TITLE: **SPECIAL PERMIT NO. 2046**, requested by Eiger Corporation, for Planned Service Commercial in the H-4 District, consisting of 73,200 sq. ft. of commercial and retail floor area with associated waiver requests, on property generally located southeast of the intersection of South 84th Street and Highway 2.

LINCOLN CITY/LANCASTER COUNTY PLANNING STAFF REPORT

P.A.S.: Annexation #03002
Change of Zone #3411 from AG and AGR to H-4 and B-5
Special Permit #2046 for Planned Service Commercial in H-4
Use Permit #150

APPIAN WAY REGIONAL CENTER PHASE II

USE PERMIT AND SPECIAL PERMIT SITE PLAN

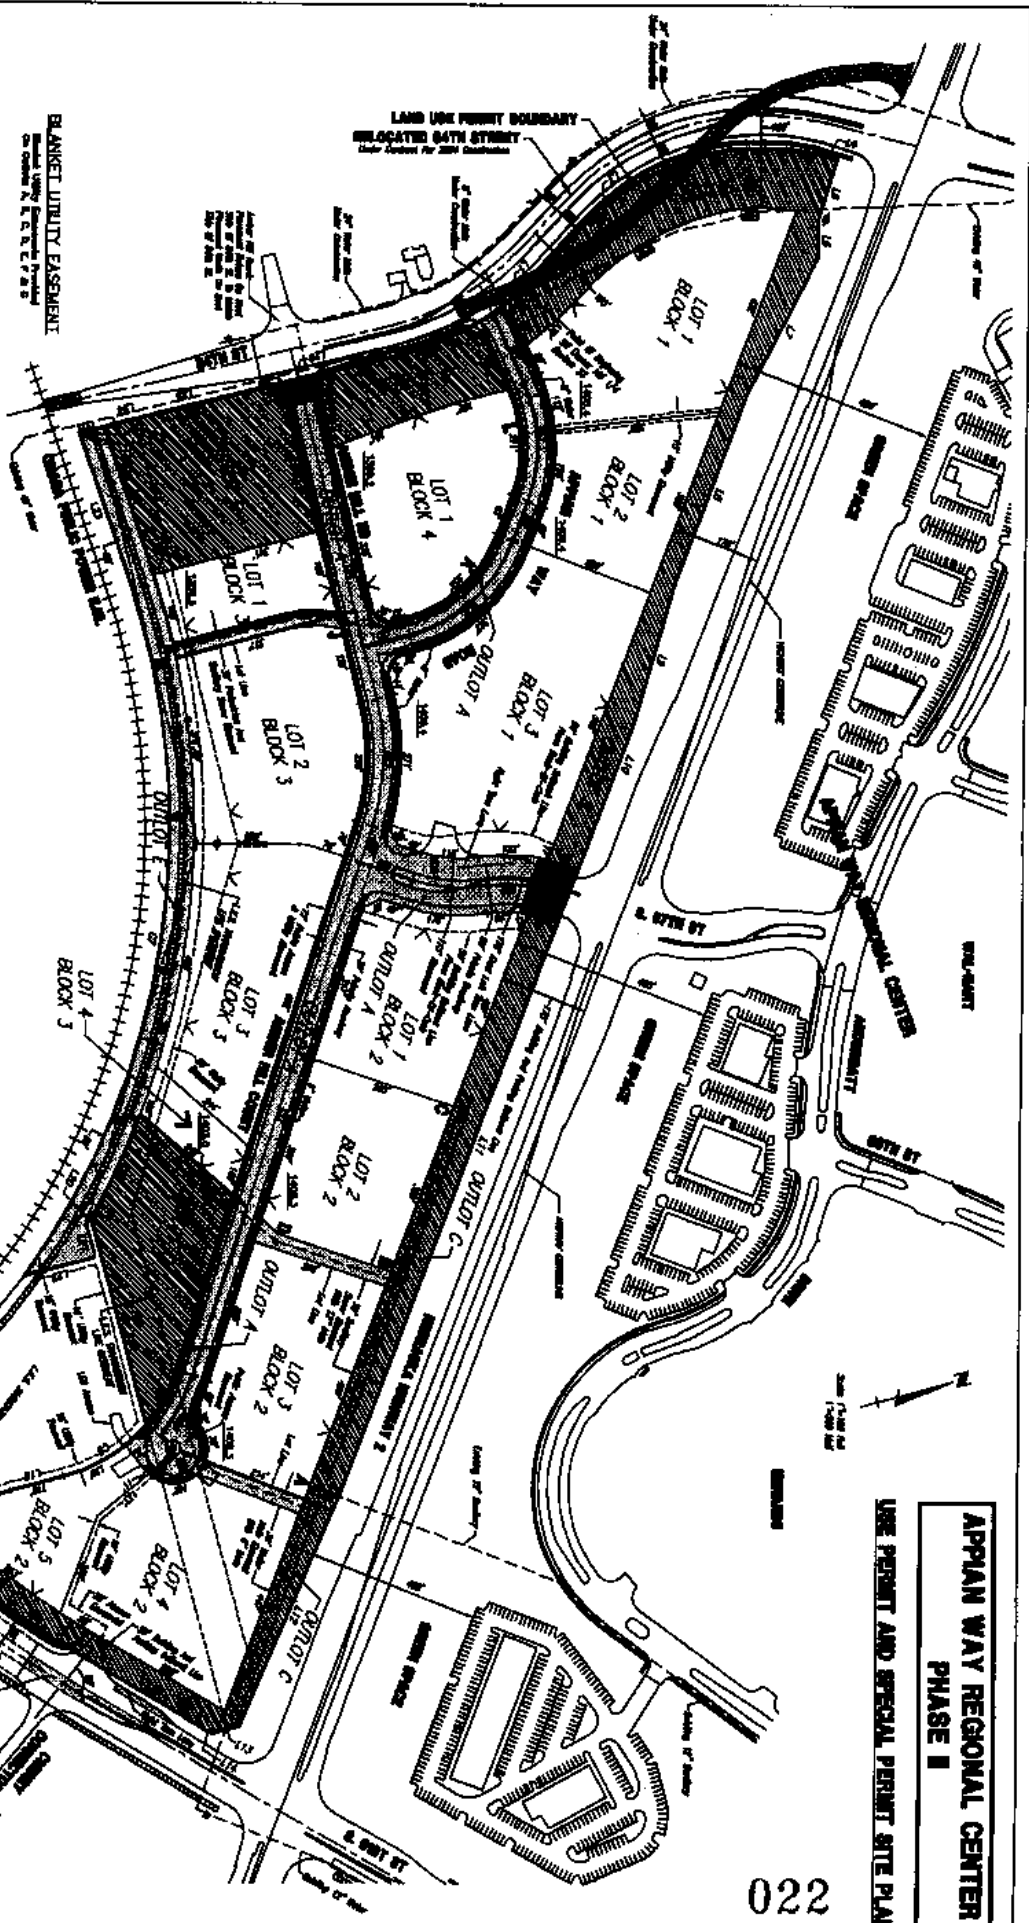
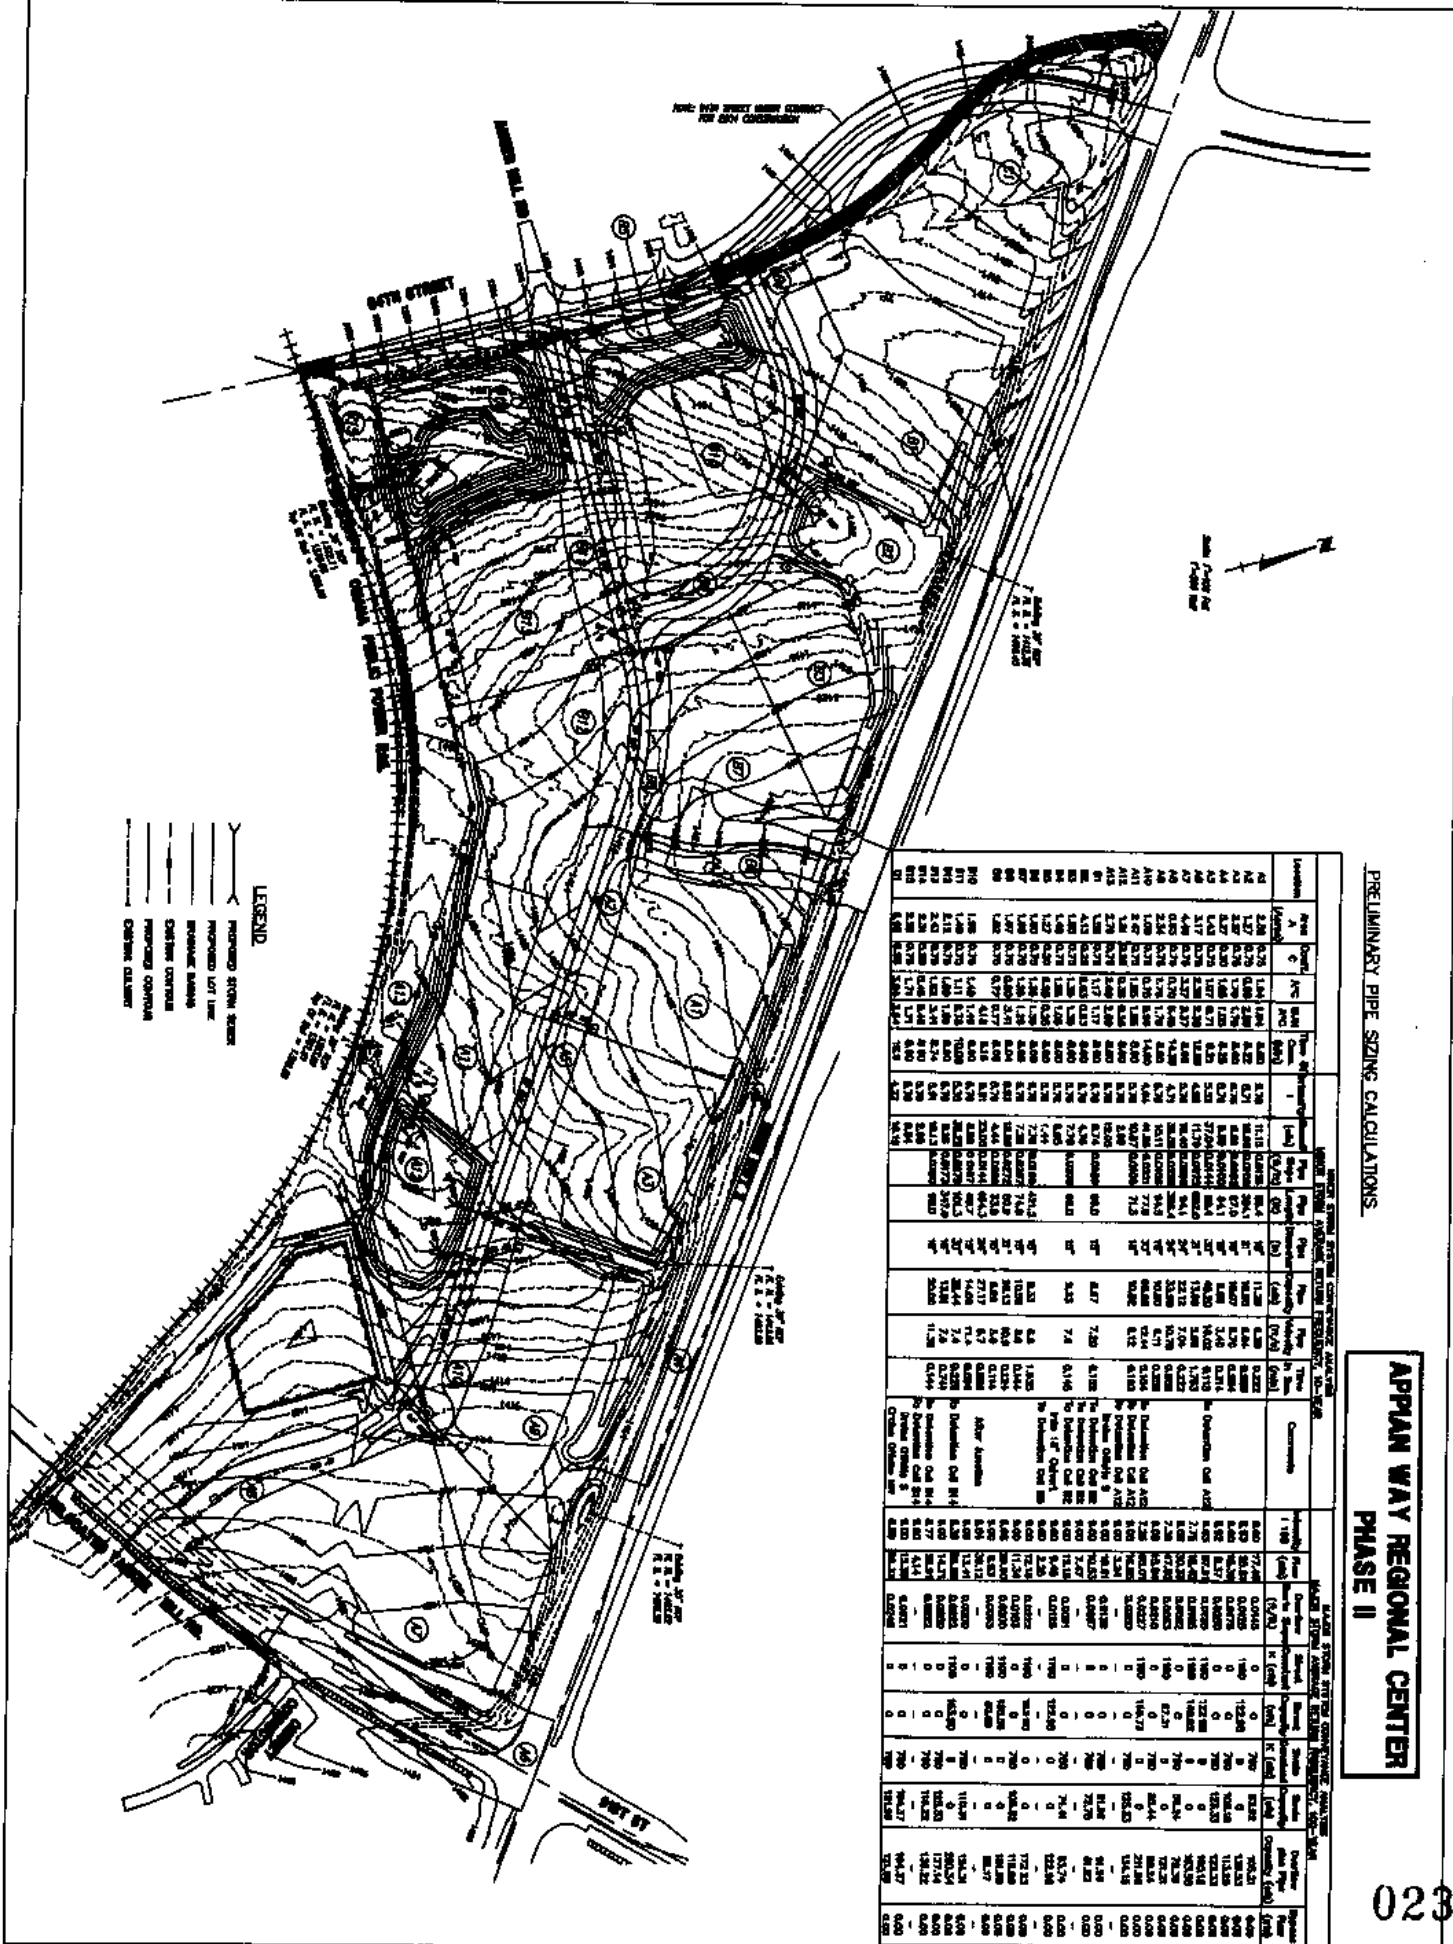
- 1.1.10 The text on Sheet 1 of 7 identifying the setbacks along Highway 2 South 91st Street amended to state “175' Setback to Buildings Parking”, and “50' Setback to Buildings and Parking”. **d**

- 1.1.11 Note #21 on Sheet 1 of 7 revised to identify the intersections being described. **d**
- 1.1.12 Note #13 on Sheet 1 of 7 revised to apply to only the B-5 district.

1.1.10 The text on Sheet 1 of 7 identifying the setbacks along Highway 2 and South 91st Street amended to state "175' Setback to Buildings and Parking", and "50' Setback to Buildings and Parking".

1.1.11 Note #21 on Sheet 1 of 7 revised to identify the intersections being described.

1.1.12 Note #13 on Sheet 1 of 7 revised to apply to only the B-5 district.

DRAINAGE PLAN
PROPOSED HYDRAULIC AND HYDROLOGY INFORMATION

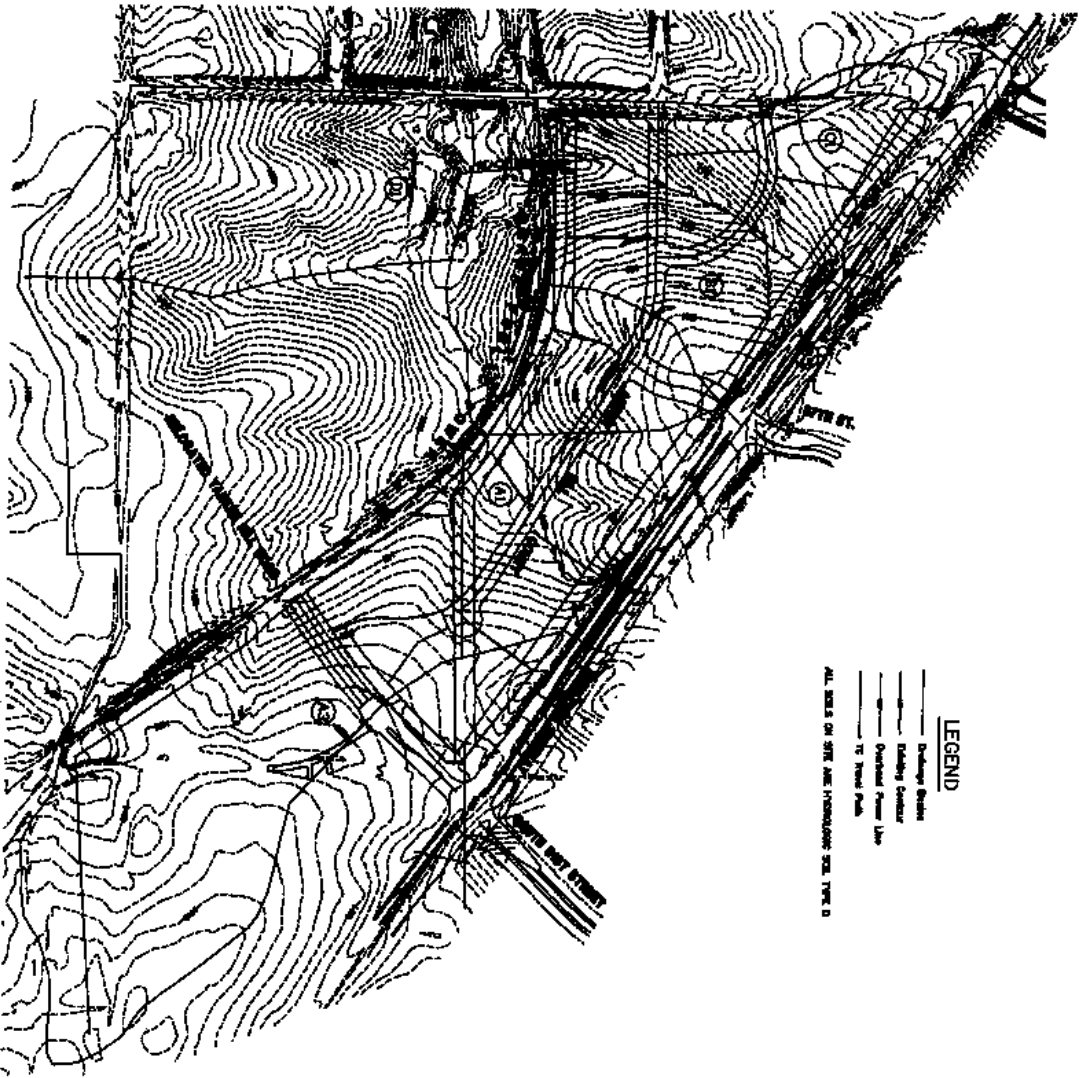
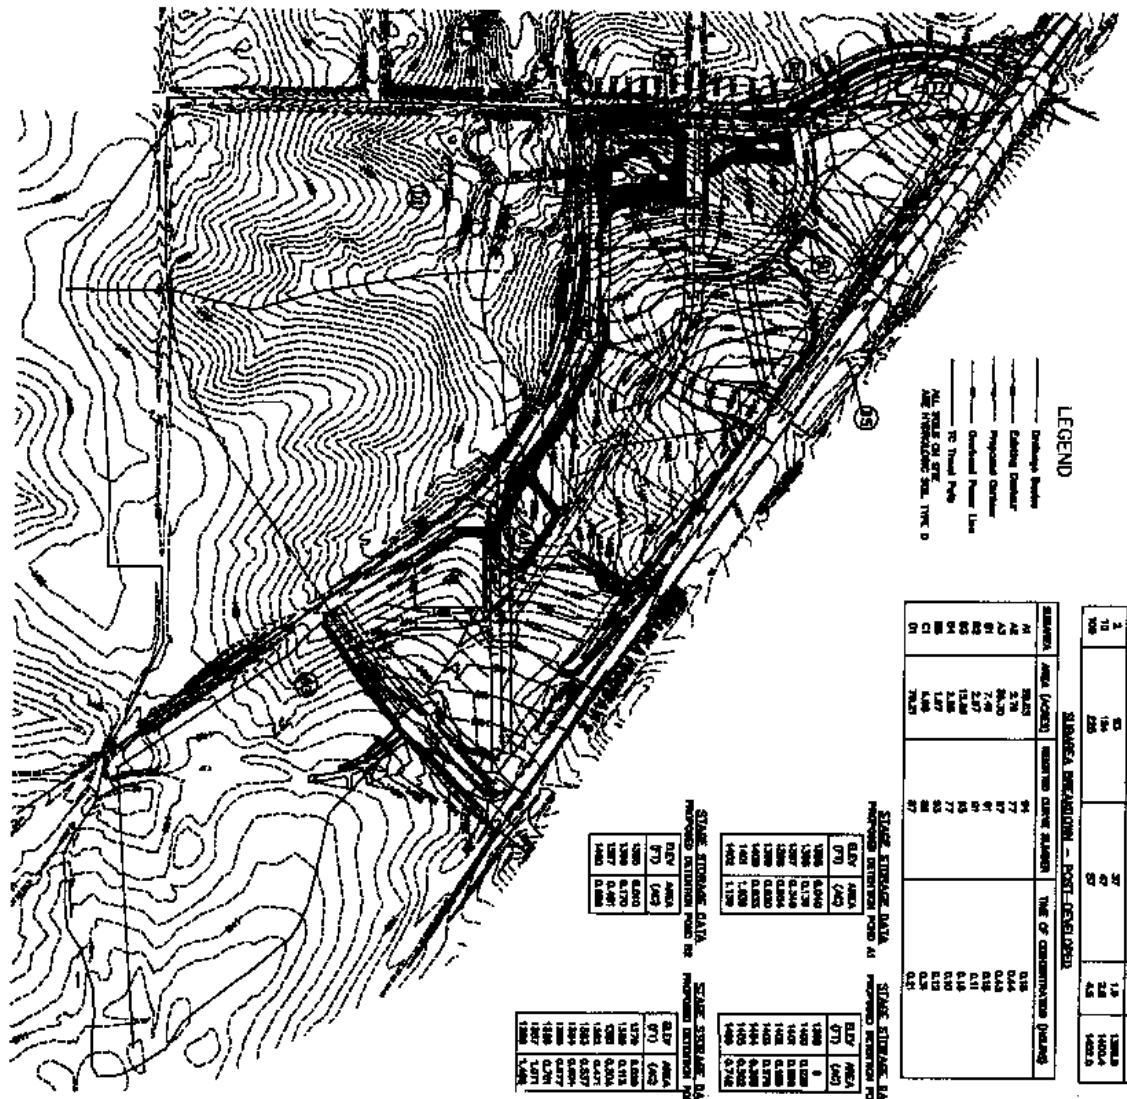
- There are sections of the sanitary sewer that are proposed to be at minimum slopes. Some of these sections are going to have low flows. It needs to be shown that the minimum velocity is achieved for the sewer given the low flow and flat slope.
- The sanitary sewer alignment near proposed manholes I & J needs to be revised. Manhole 'I' can be eliminated by revising the alignment.

Grading/Drainage - The proposed contours for South 84th Street and for Yankee Hill Road need to be shown on the grading plans.

- The inlets into detention cell B3 appear to outlet onto a platform above the main area of the cell. There appears to be an overflow spillway for the platform to the main area of the cell. This overflow area will need some stabilization treatments to prevent erosion on the spillway slope.
- Show minimum opening elevations for all lots abutting proposed detention cells and drainage ditches.
- The site plan shows areas of existing delineated wetlands on the site. Any disturbed wetland area will be required to be mitigated through an Army Corps of Engineers 404 Permit at the appropriate area ratios. Show on the plans the areas designated for mitigated wetlands or comment on the intended plan for mitigation.

LEGEND
 ○ TREES TO BE PLANTED ALONG HWY 2
 ○ EXISTING TREE MARK

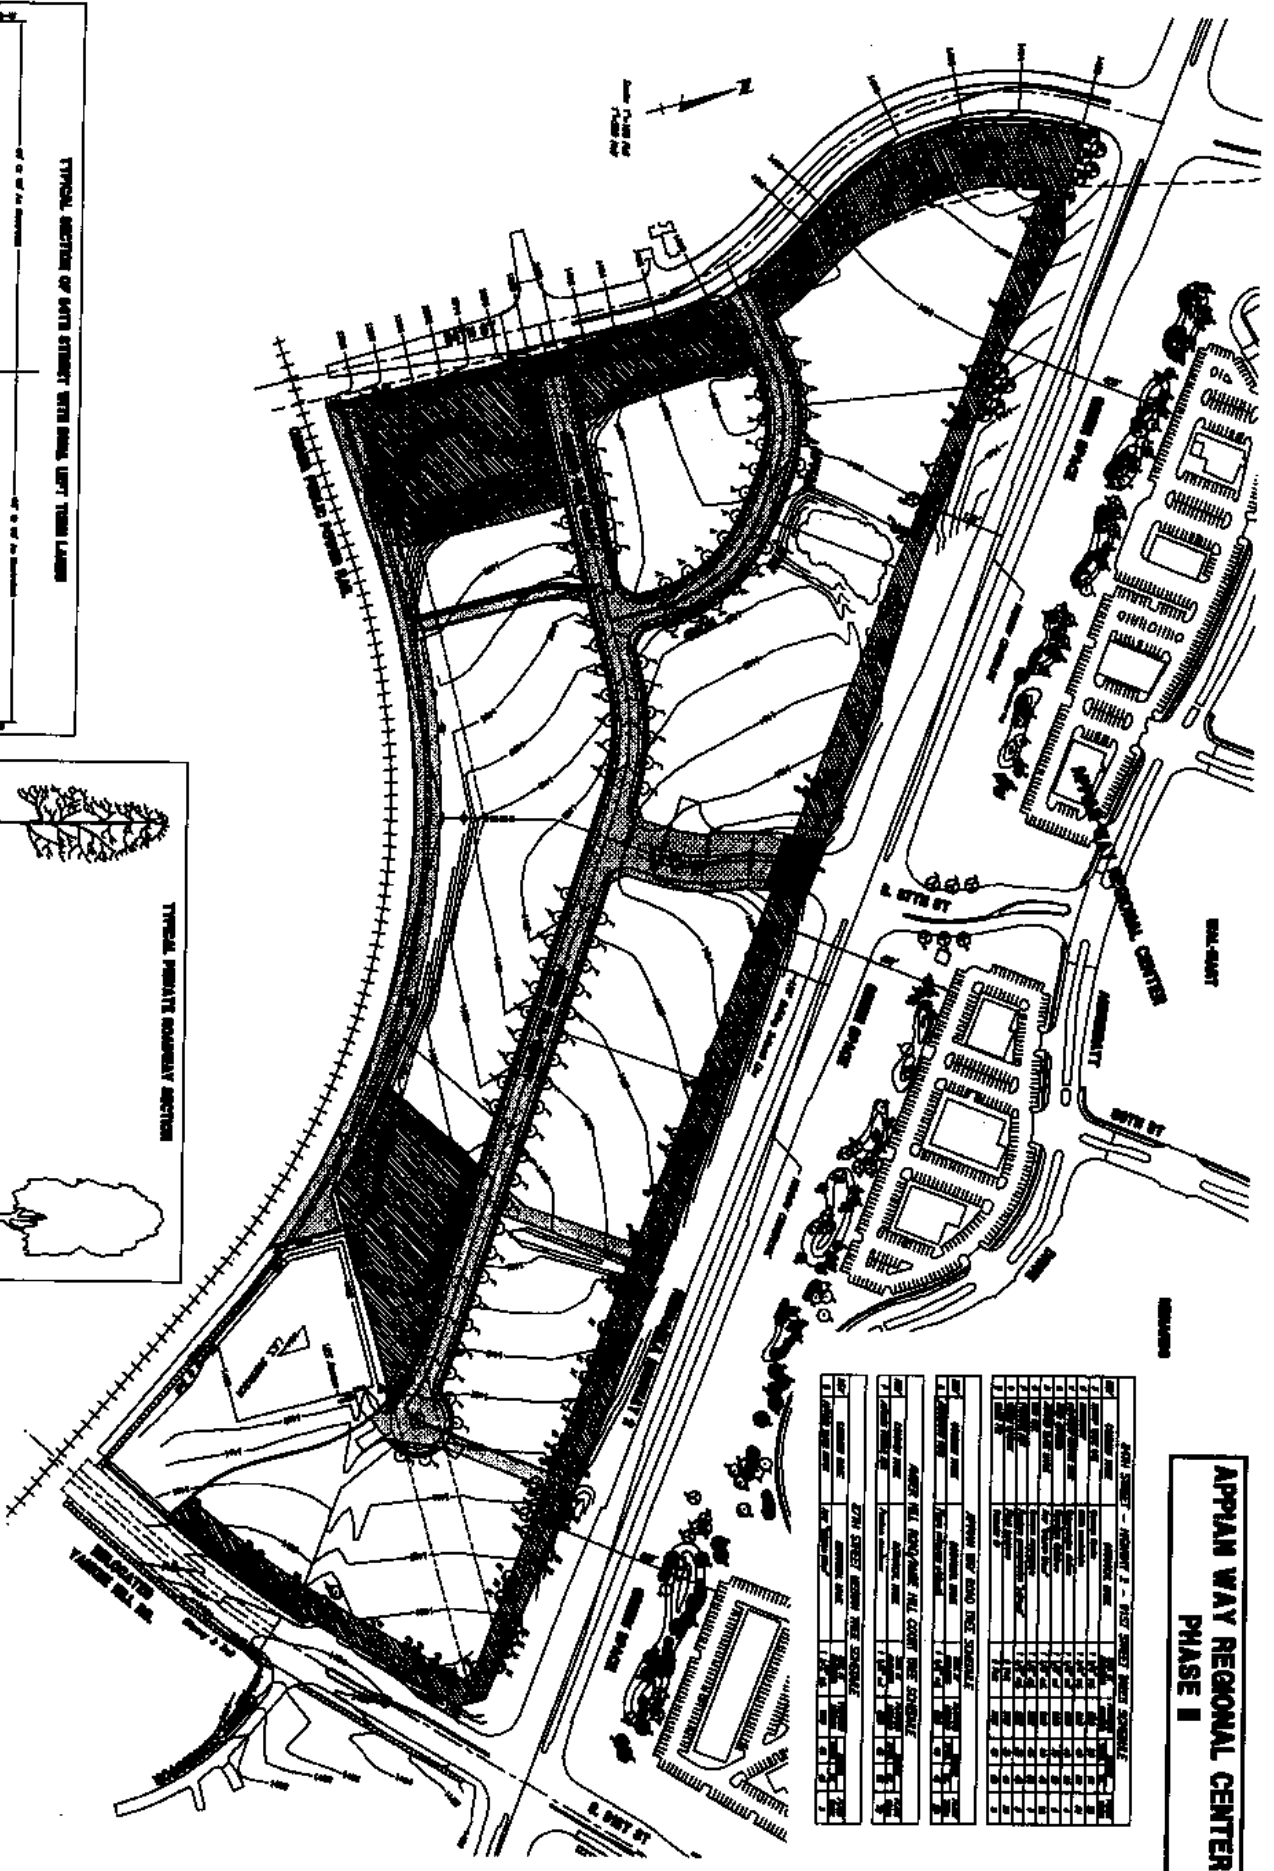
1. Scotch Pine and Austrian Pine are not acceptable tree species due to susceptibility to diplodia and other diseases. Please substitute with Colorado Green Spruce, Colorado Blue Spruce, Concolor Fir, Black Hills Spruce, or other hardy evergreen species.
2. Please provide public access easement and grade trail alignment with platform in conjunction with the adjoining development.
3. Pin Oak is not an acceptable tree species due to susceptibility to chlorosis. Please substitute with Swamp White Oak.
4. Street tree species are assigned to the following streets and/or private drives:
Appian Way Road – Aristocrat Pear
Amber Hill Road/Amber Hill Court – Autumn Purple Ash
S. 87th Street – Autumn Blaze Maple (NE Highway 2 to Amber Hill Road)
5. All private roadways need to be identified and labeled as such on the landscape plan.
